Date: 8/8/2017  
To: Cottonwood Heights City Council members

**REF: 8/8/2017 WORK SESSION, AGENDA, Item #2. High-T Intersection.**

**The re-configuration of intersection SR-210 and Wasatch Blvd, as proposed by UDOT, in respect specifically to the High-T 'free flow' northbound lane:**

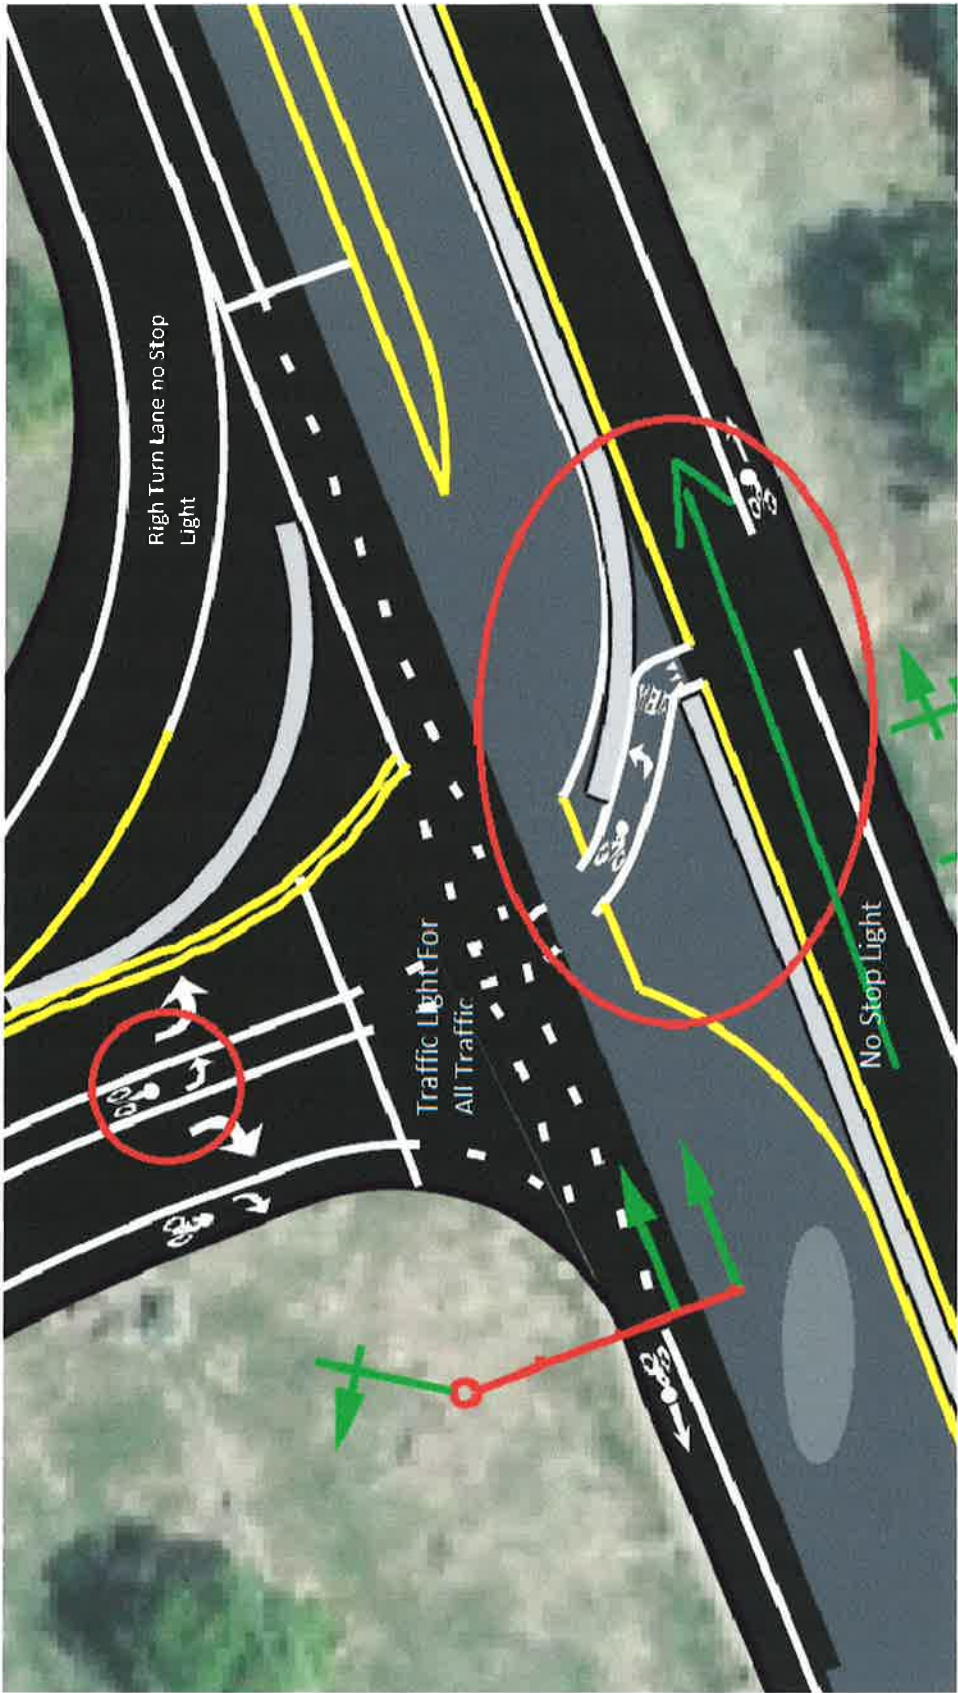
**In downgrading the safety of the intersection this project endangers both cyclists and pedestrian species.**

**S 3500 E & Wasatch intersection, ped-x-ing:**

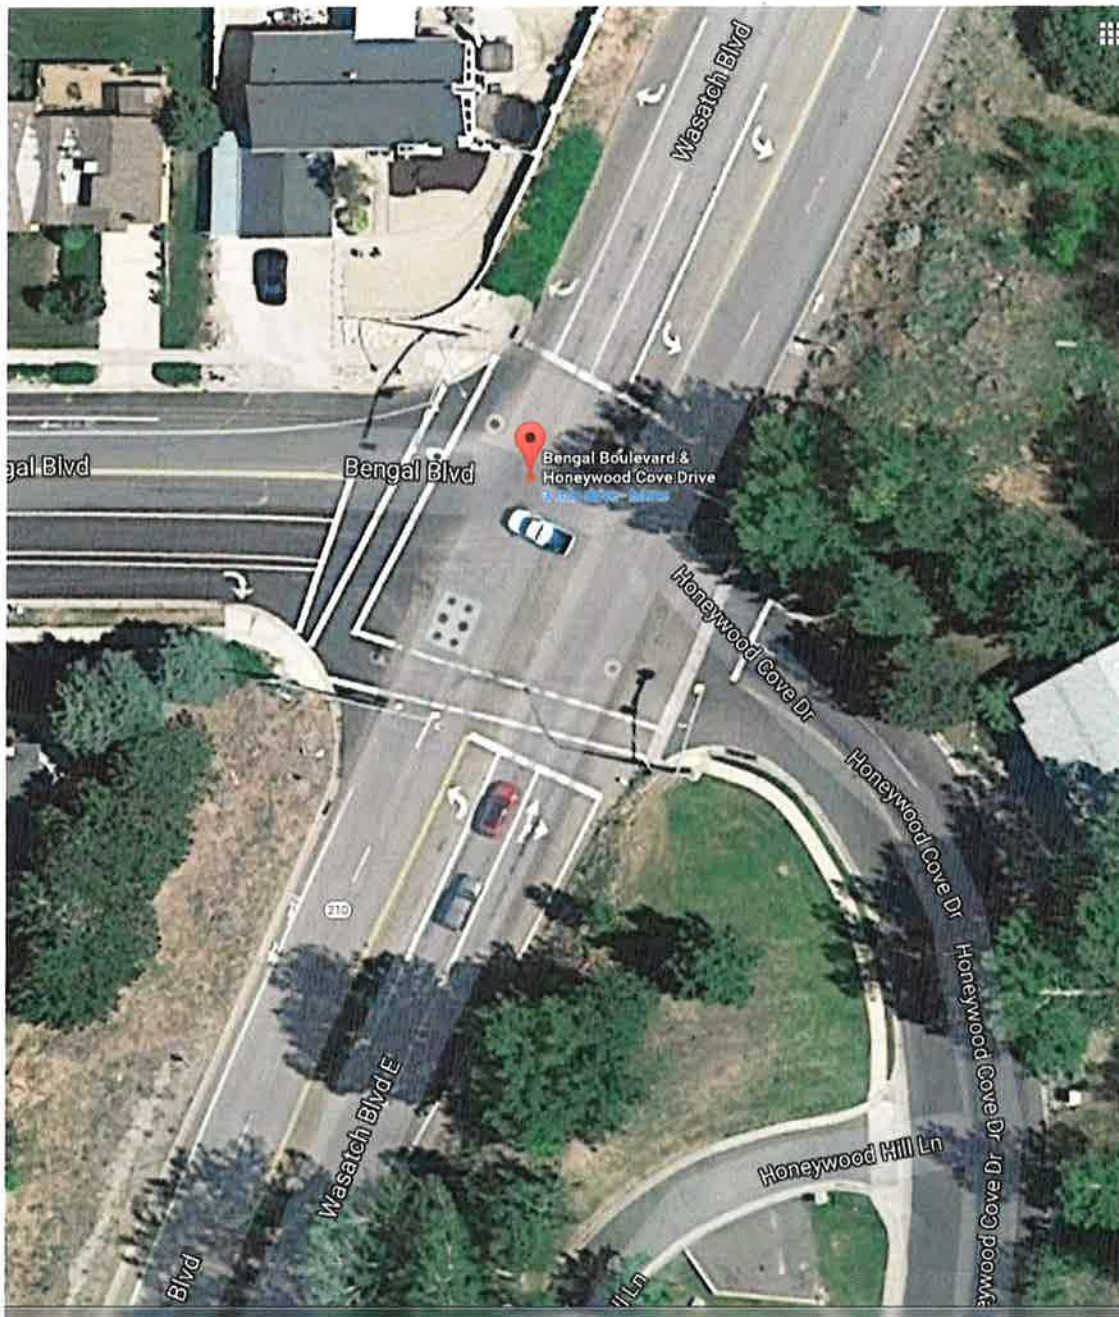
2. 'fails to address safe pedestrian passage though the intersection via ped-x signal or crosswalks; immediate areas within this part of the community are growing, and necessitates a need for safe pedestrian passage though this intersection. Other intersections north on Wasatch provide pedestrian cross-walks;
